# Access Compliance Report

## Public Rights-of-Way

### (Curb Ramps)

Intersection ID: 16232	Main Street: ANSON_ST	Cross Street: HOLLIS_RD	Location: N
ADA ID: B63DB72F2416	Ramp Type: Directional1	Initial Pass/Fail: Fail	Overall Compliance: No
		Severity Score: 1.25

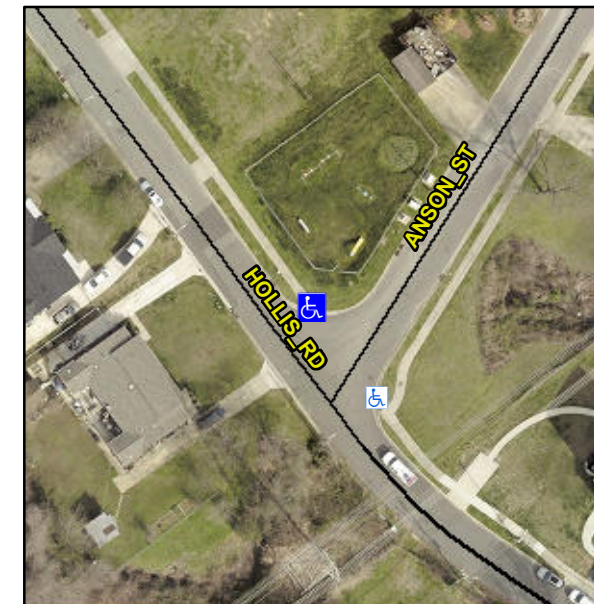
**R304.5.3**

Compliance	Description	Data	Compliance	Description	Data
N/A	Ramp Length (in)	62.0	N/A	Grade Break?	N/A
Yes	Ramp Width (in)	59.0	N/A	Grade Break Slope (%)	0.0
Yes	Ramp Slope (%)	1.1	N/A	Grade Break XSlope (%)	0.0
No	Ramp XSlope (%)	3.6			
N/A	Flare Type LT	N/A	N/A	Flare Type RT	N/A
N/A	Flare Slope LT (%)	N/A	N/A	Flare Slope RT (%)	0.0
N/A	Flare Traversable LT?	N/A	N/A	Flare Traversable RT?	N/A
N/A	Landing Length (in)	0.0	N/A	DWS Provided?	N/A
N/A	Landing Width (in)	0.0	N/A	DWS Contrast?	N/A
N/A	Landing Slope (%)	0.0	N/A	DWS Length (in)	N/A
N/A	Landing X Slope (%)	0.0	N/A	DWS Full Width?	N/A
N/A	Landing Curb? (Y/N)	N/A	N/A	DWS Offset LT (in)	N/A
N/A	Shared Landing?	N/A	N/A	DWS Offset RT (in)	N/A
N/A	Gutter Ponding?	0.0	N/A	Gutter Slope (%)	N/A
N/A	Gutter Lip Ht (in)	0.0	N/A	Gutter X Slope (%)	N/A
N/A	Painted X Walk1?	No		Road Slope (%)	3.4
	X Walk 1 Direction	To SE		Road X Slope (%)	1.7
	X Walk 1 Width (in)	N/A		Clear Space?	N/A

**Remove & Replace Entire Ramp.**
